# City of Hurricane

## AGENDA

### OF A MEETING OF THE HURRICANE CITY PLANNING COMMISSION

Thursday, December 12, 2019

### Final Site Plan review

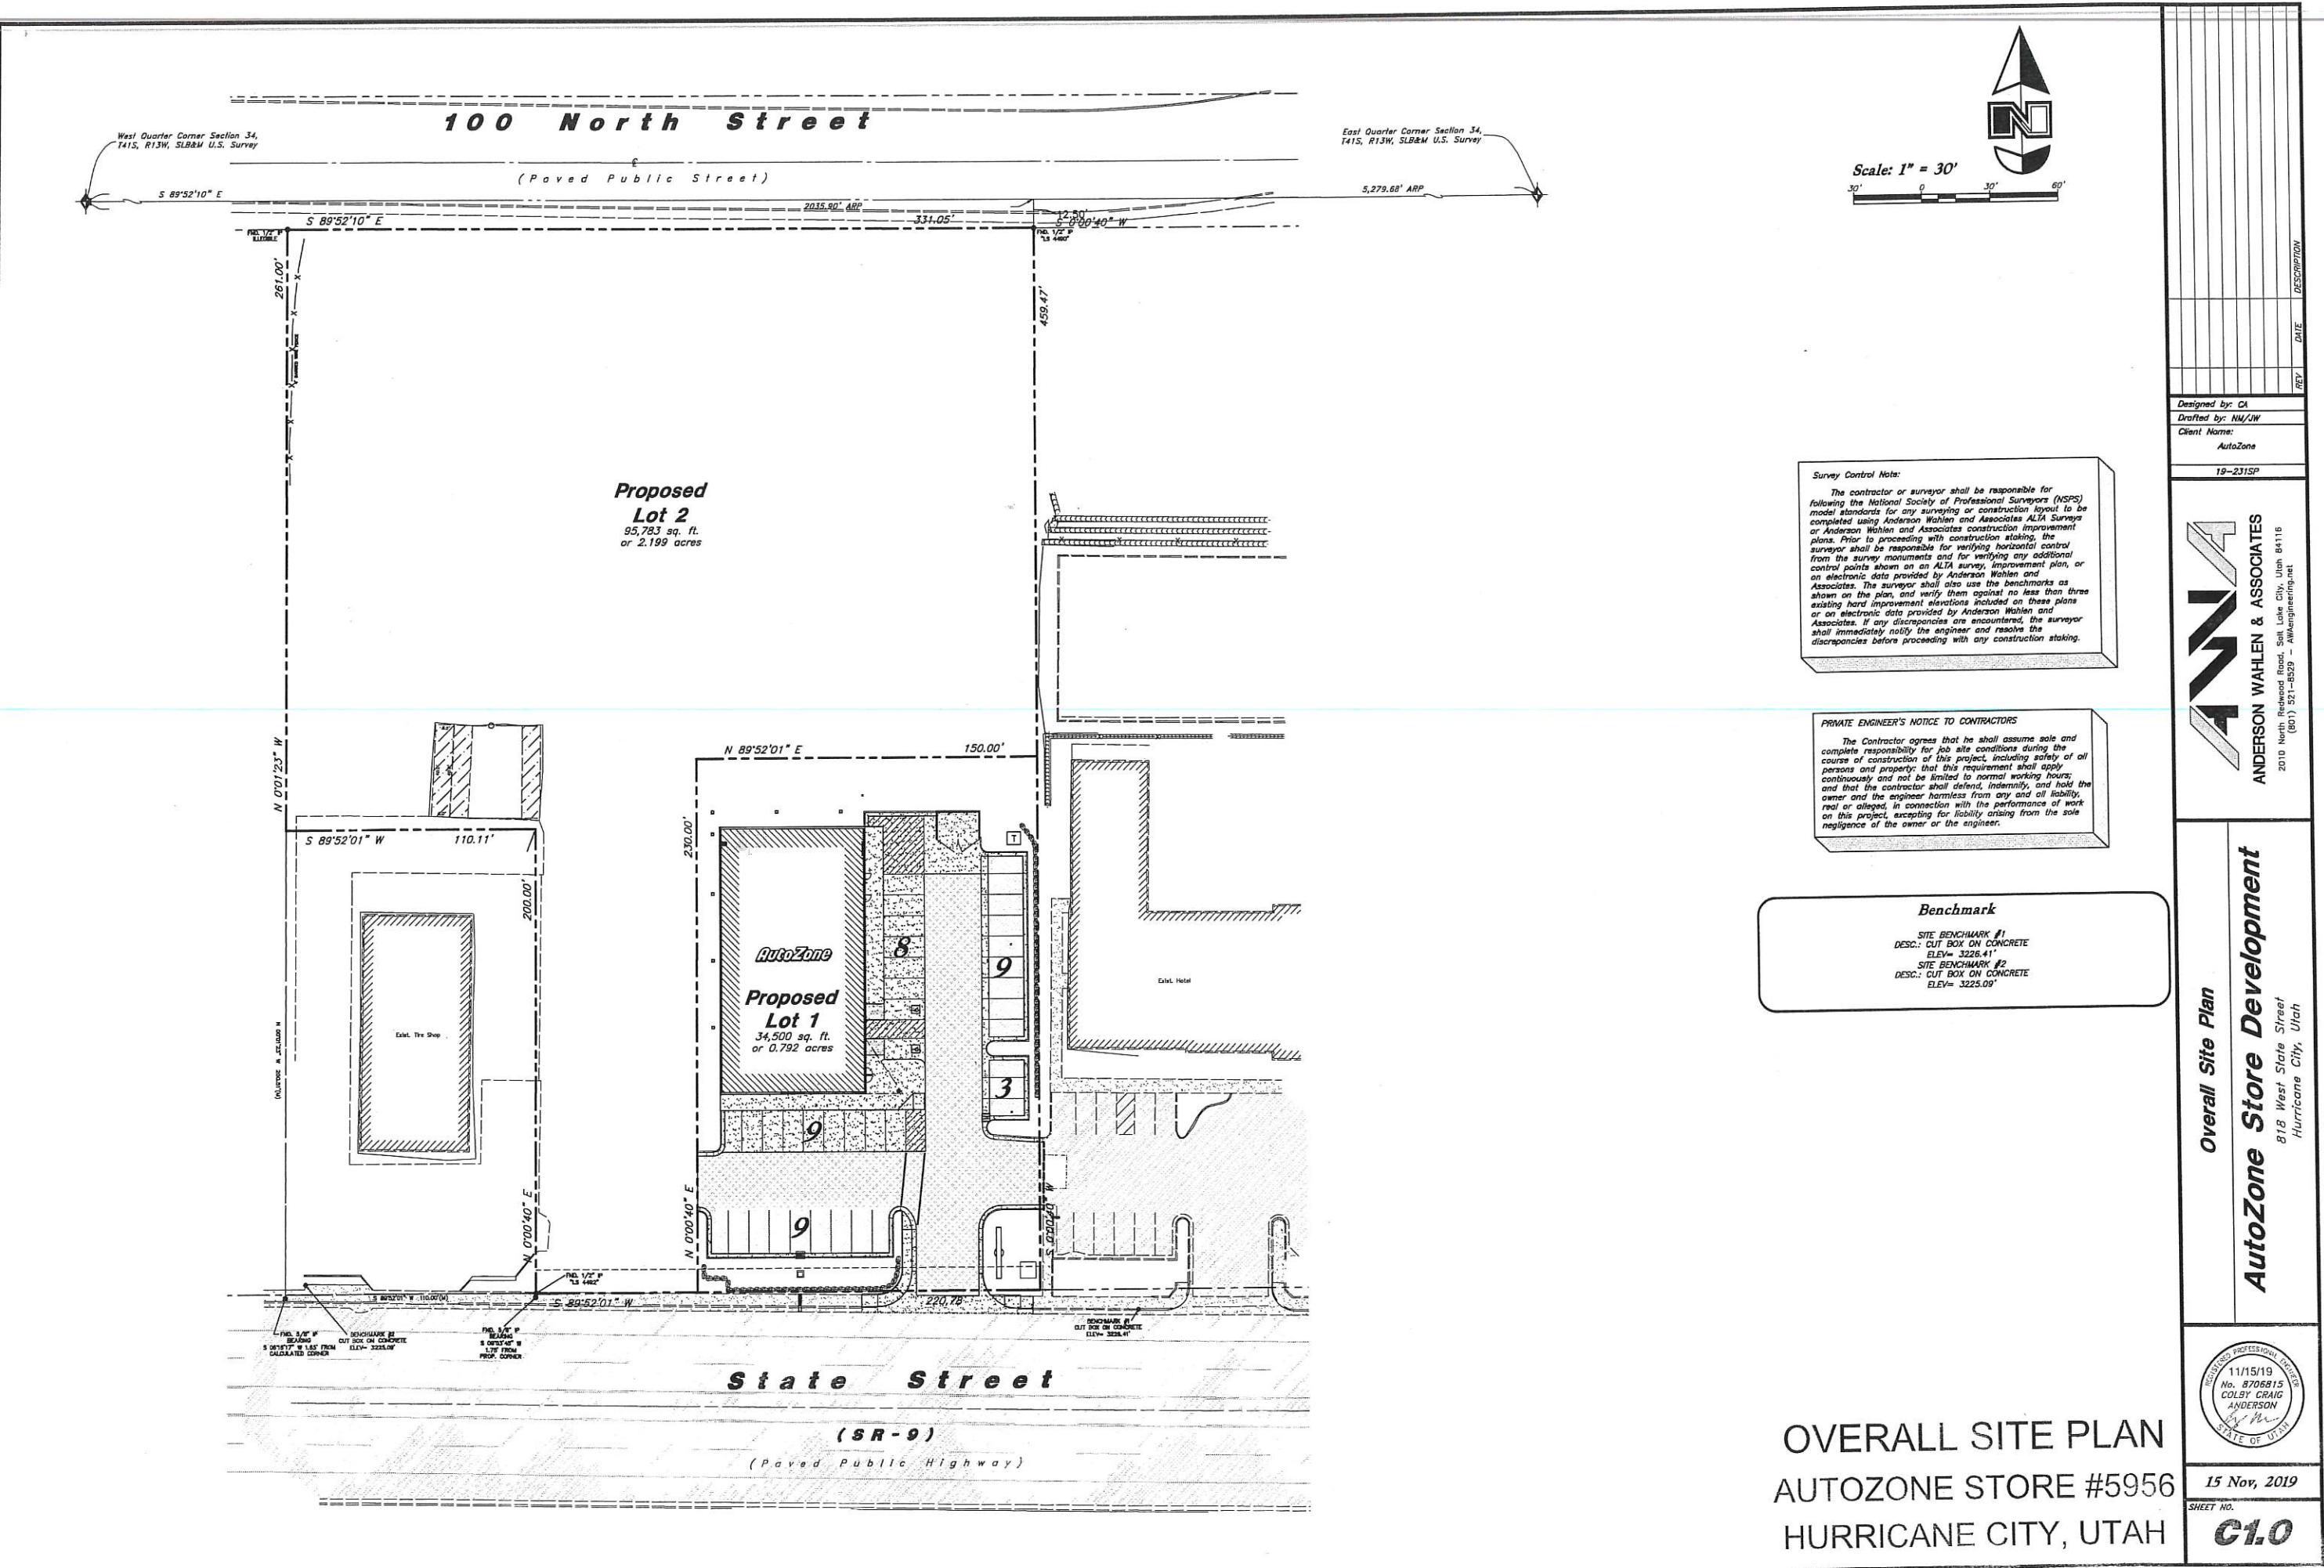
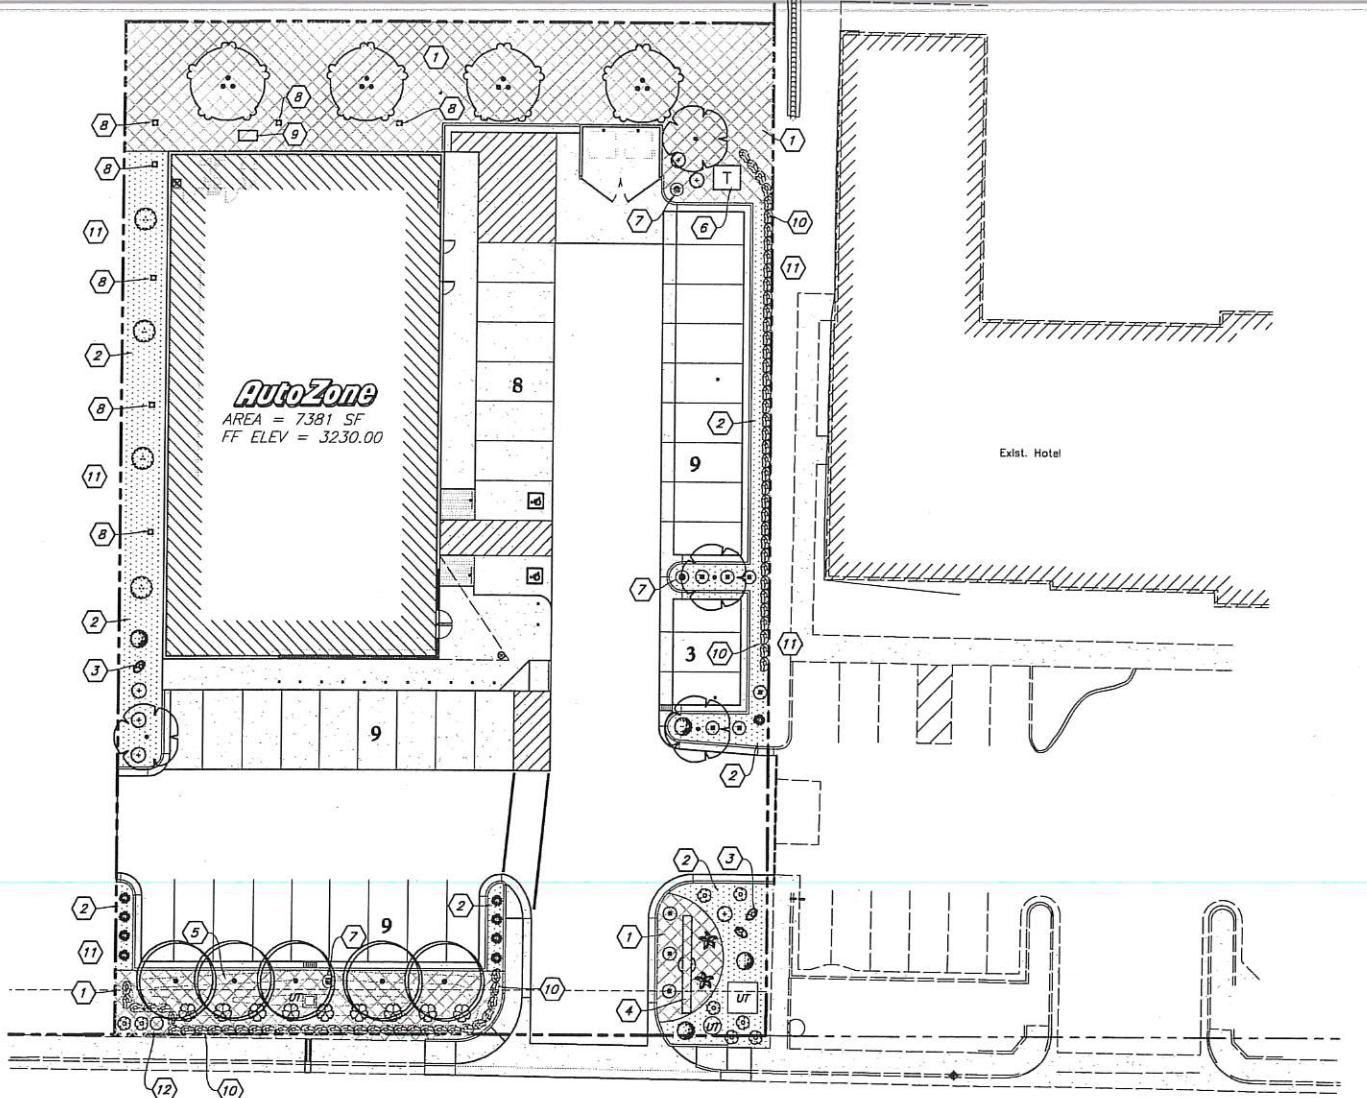
1. Parking meets minimum requirements for number of spaces and provides 8 spaces more than required.
2. The site plan shows the building located behind the parking lot facing east with landscaping along all four sides of the property.
3. Elevations are of an attractive single story concrete masonry building in tan and brown colors.

4. The landscape plan includes landscaping within the detention basin, along the west side of the building, at the back of the property, and along all perimeter parking spaces. Watering is via drip systems, as required. Three tree species and 8 different shrubs are planned.

5. A sign is shown east of the driveway. This section of the code recommends a monument sign but it is not required: 10-36-7: SIGN DEVELOPMENT STANDARDS:*A. Monument signs are encouraged in all planned commercial zones and commercial zones located along the commercial corridor of SR-9.* A sign permit is required before signs are installed unless they are approved with the site plan. Without sign details this sign can't be approved with the site plan. Wall signs are within code and can be approved with the site plan.

6. Parking lot and building lighting is specified. Applicant has provided a luminaire detail for the building wall lights and the parking lot lights. A house shield is located on the building wall lights and both are down facing fixtures. However, the specifications show a 4,000 K light and that will have to be reduced to a 3,000K light to meet standards.

**Recommendation:** Staff recommends approval of this final site plan subject to lights being changed to meet City standards.
